ADDENDUM NO. 2

**STOUT FIELD BUILDING 18
MILITARY INTELLIGENCE BATTALION CONVERSION
INDIANAPOLIS, INDIANA**

IFB NO: MDI-SAB-24-B-014

GEDA Architects

ABI 1
C100.1

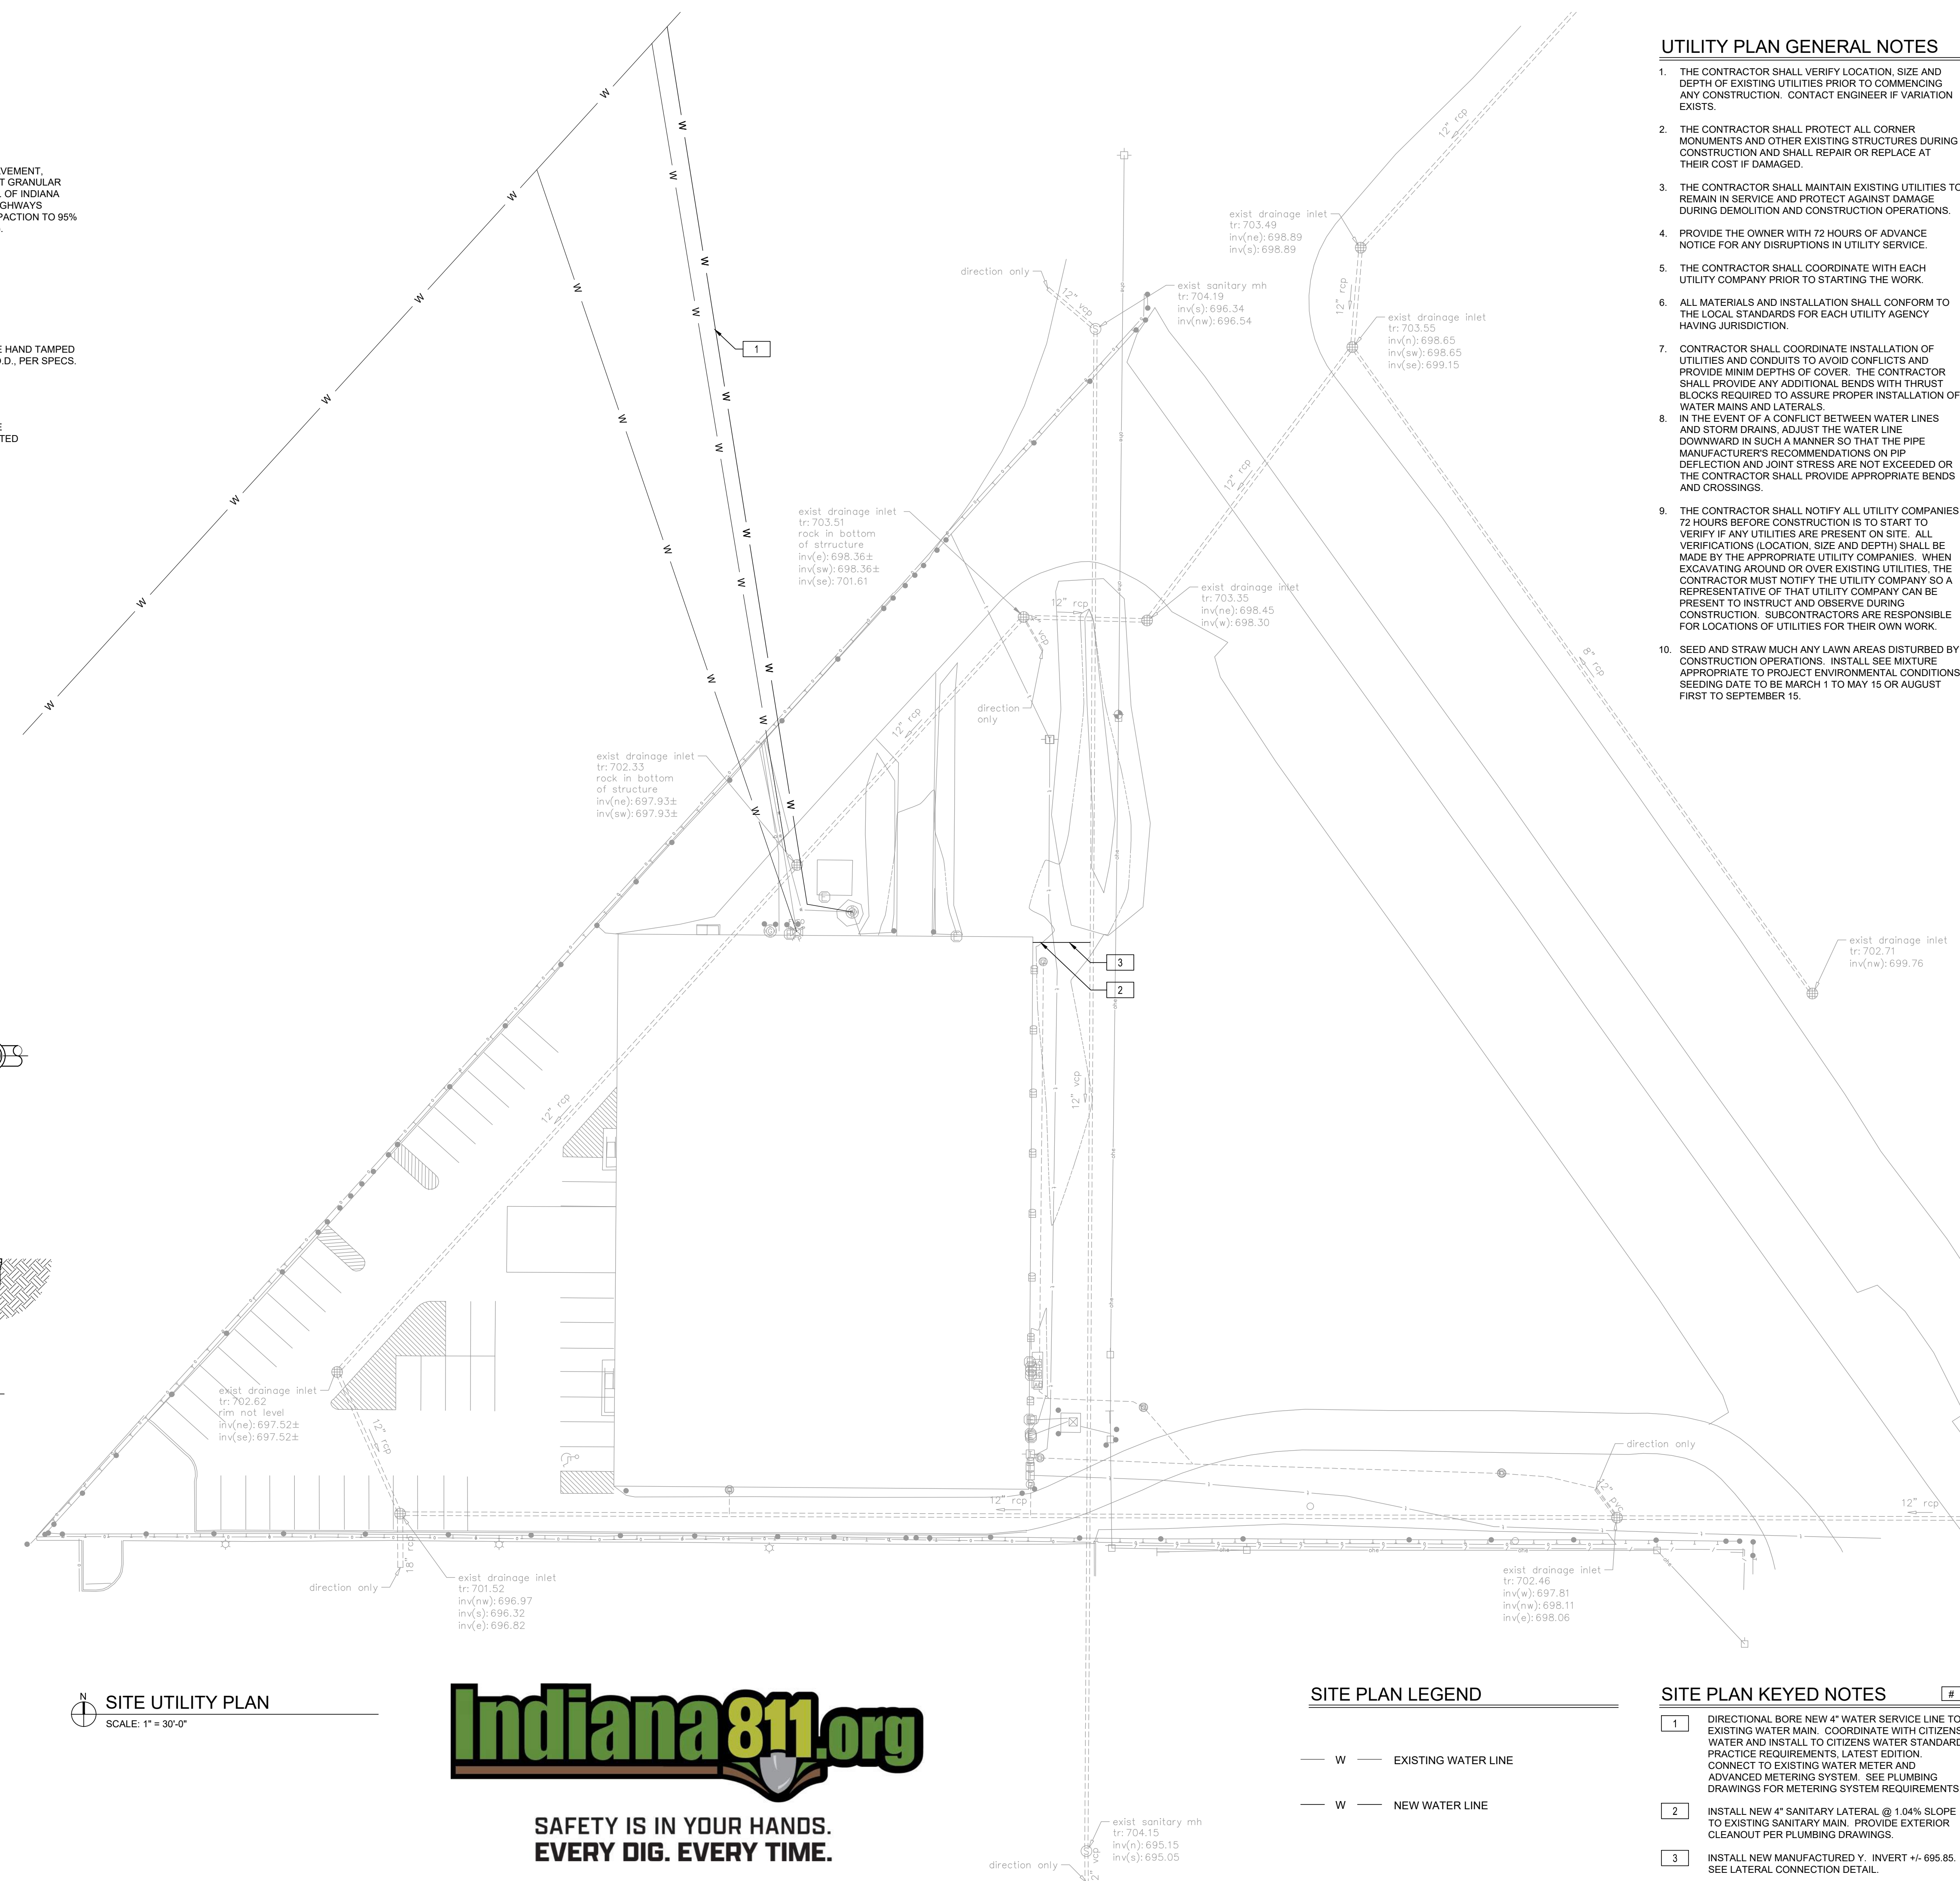
1. Sheet C100.1 – ABI 1 - SITE UTILITY PLAN
 - Add Sheet to the drawing set.
2. Sheet A102 – REFLECTED CEILING PLAN
 - Removed lay-in ceiling from plan drawing in Rooms 113, 113A and 117A

A102

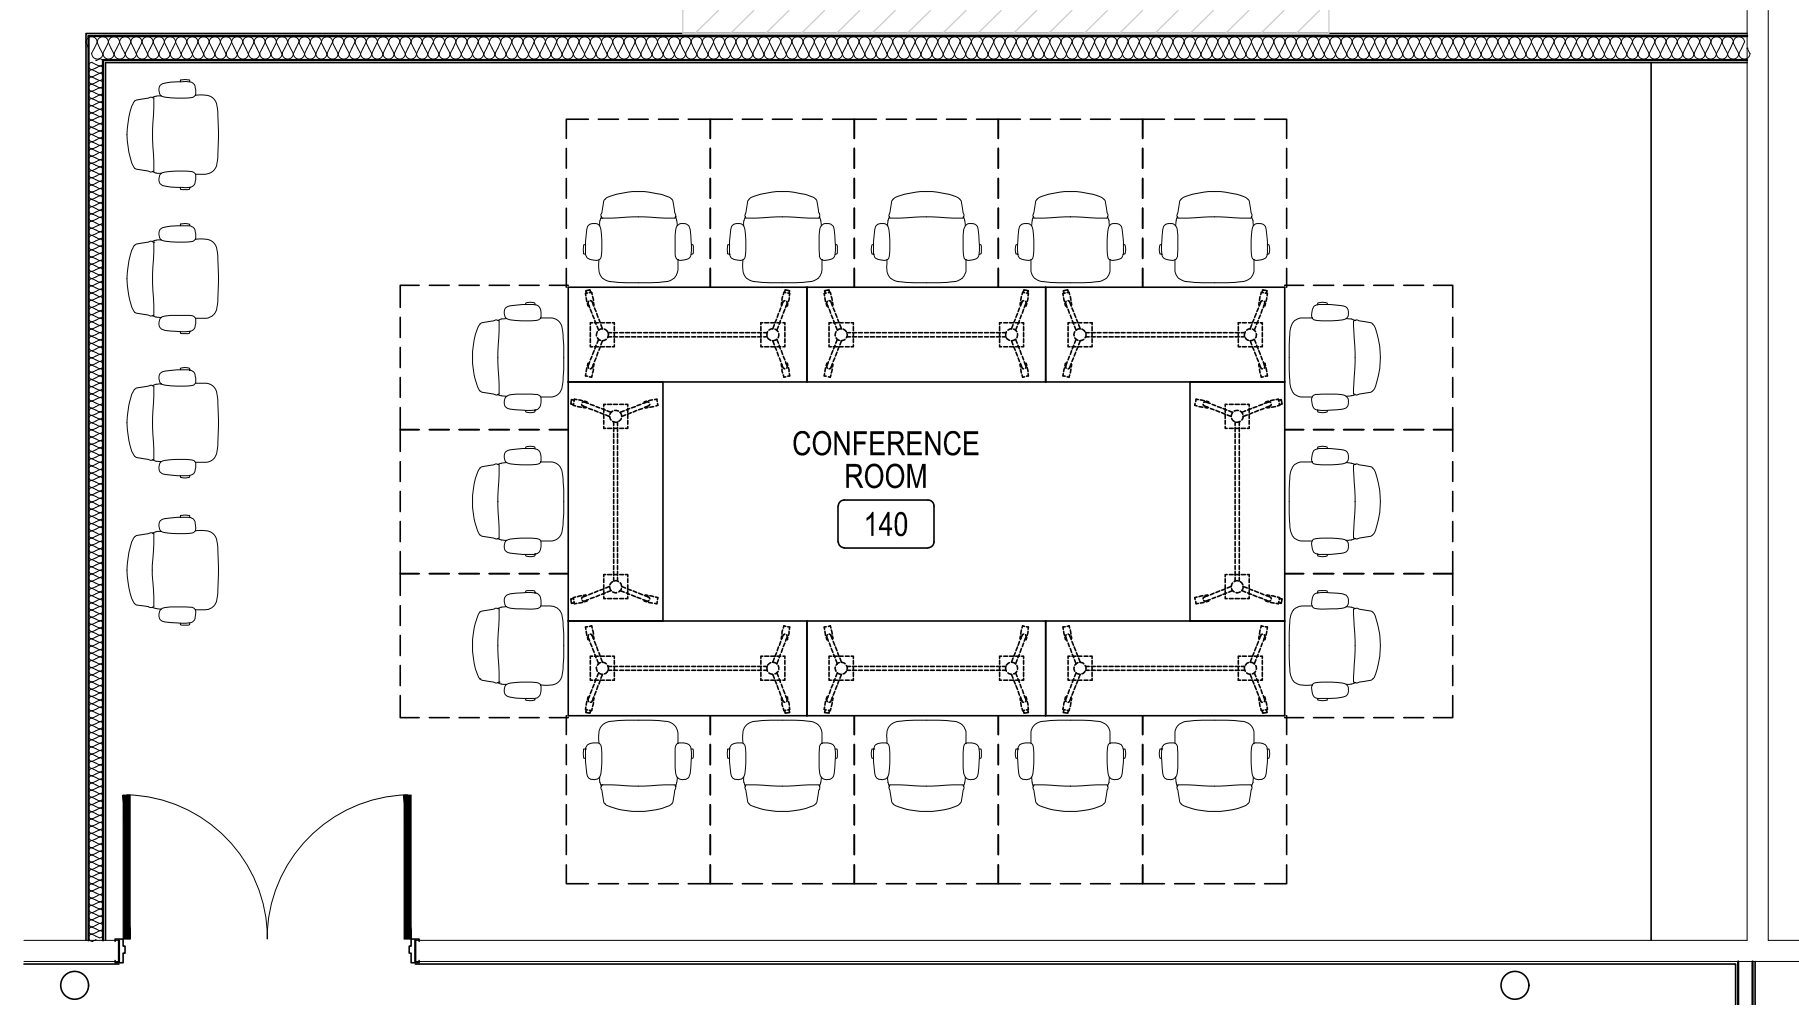
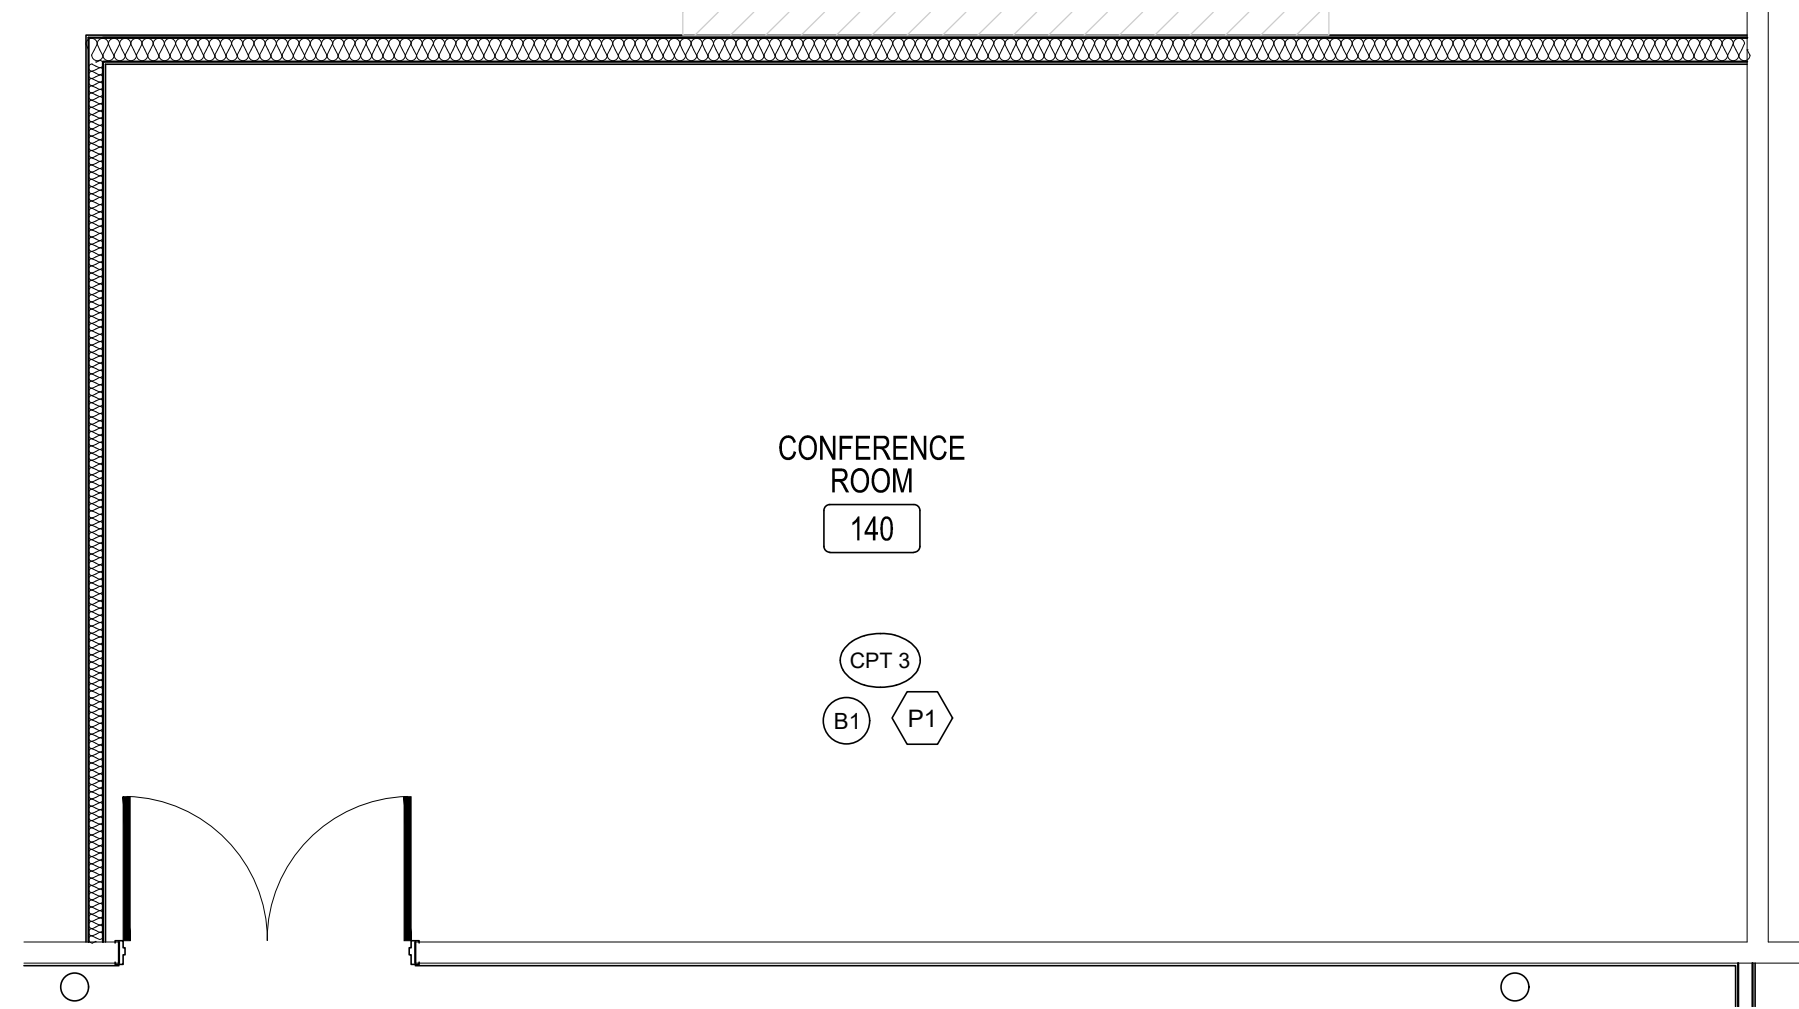
- Revised ceiling design in Corridor 1
 - Added Ceiling Type 3 and Ceiling Type 4 to RCP Keynotes
3. Sheet A101.2 – ALTERNATE BID ITEM 2, REFLECTED CEILING PLAN, FF&E AND FLOOR PLANS

ABI 2
A101.2

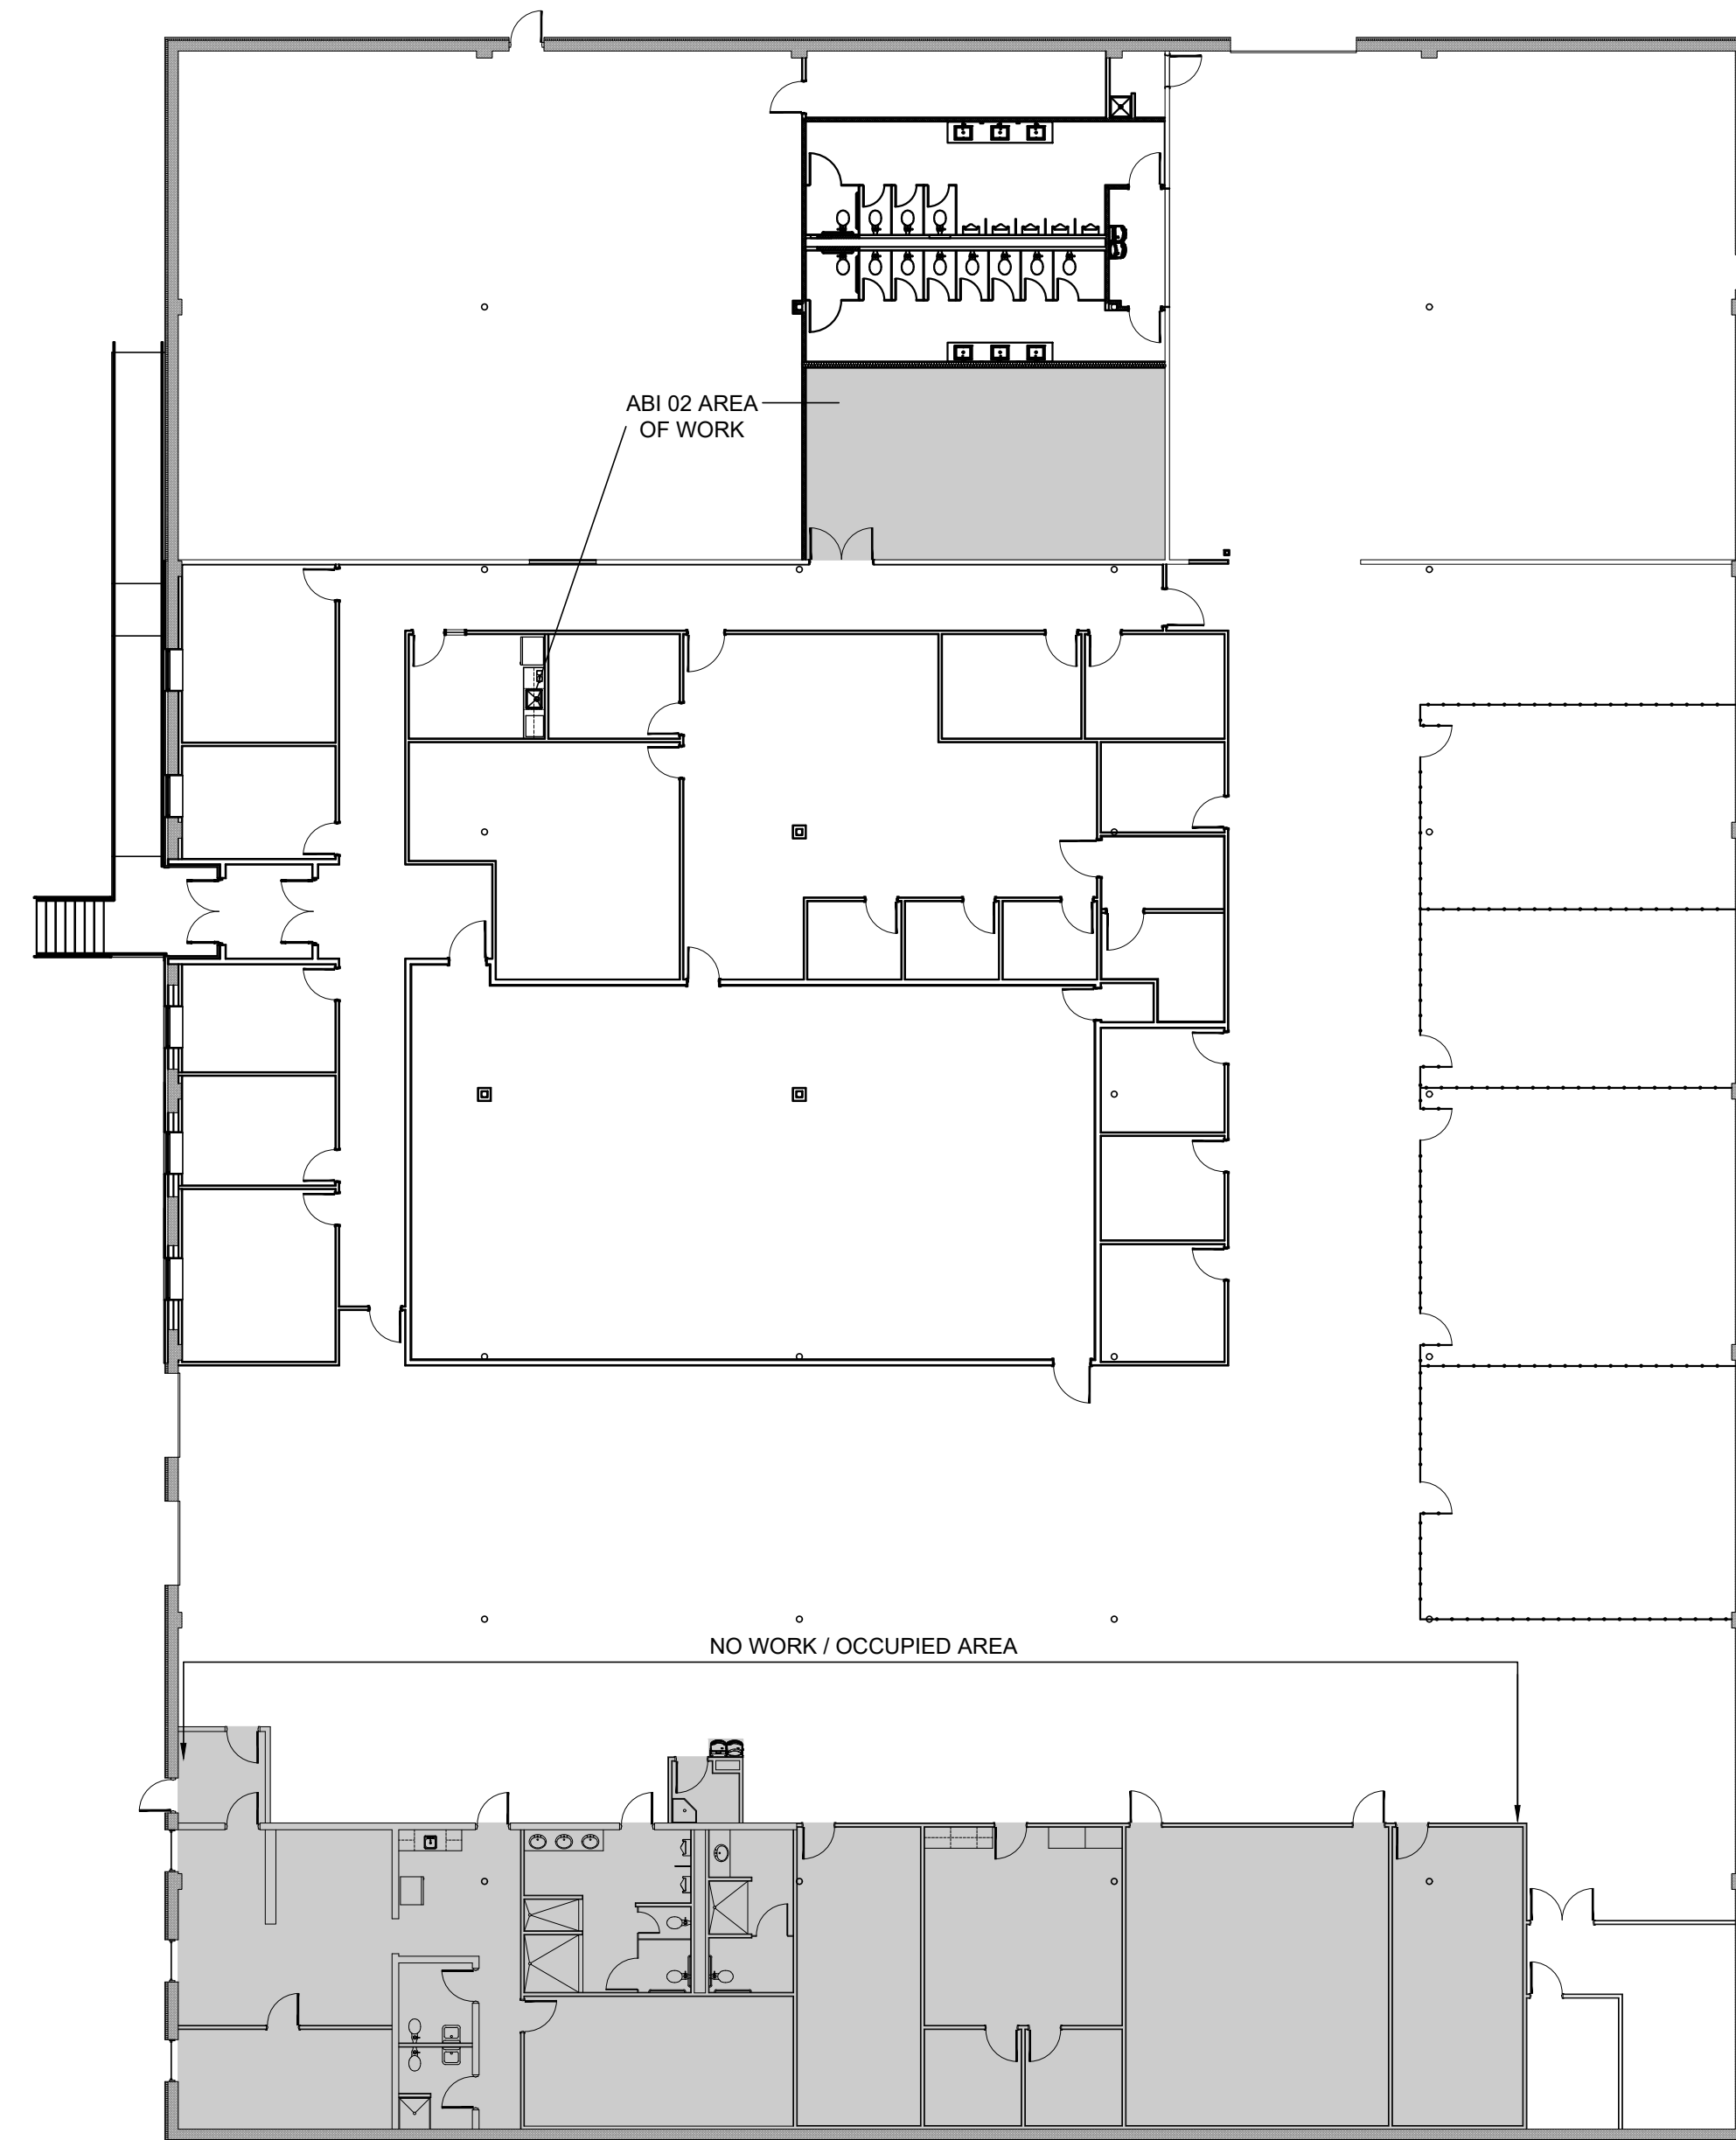
- Revised ceiling design in Room 140
4. Sheet EL101 – FIRST FLOOR LIGHTING PLAN
 - Keynote 1 revised to provide additional information on mounting of light fixtures in Open Classroom 117.
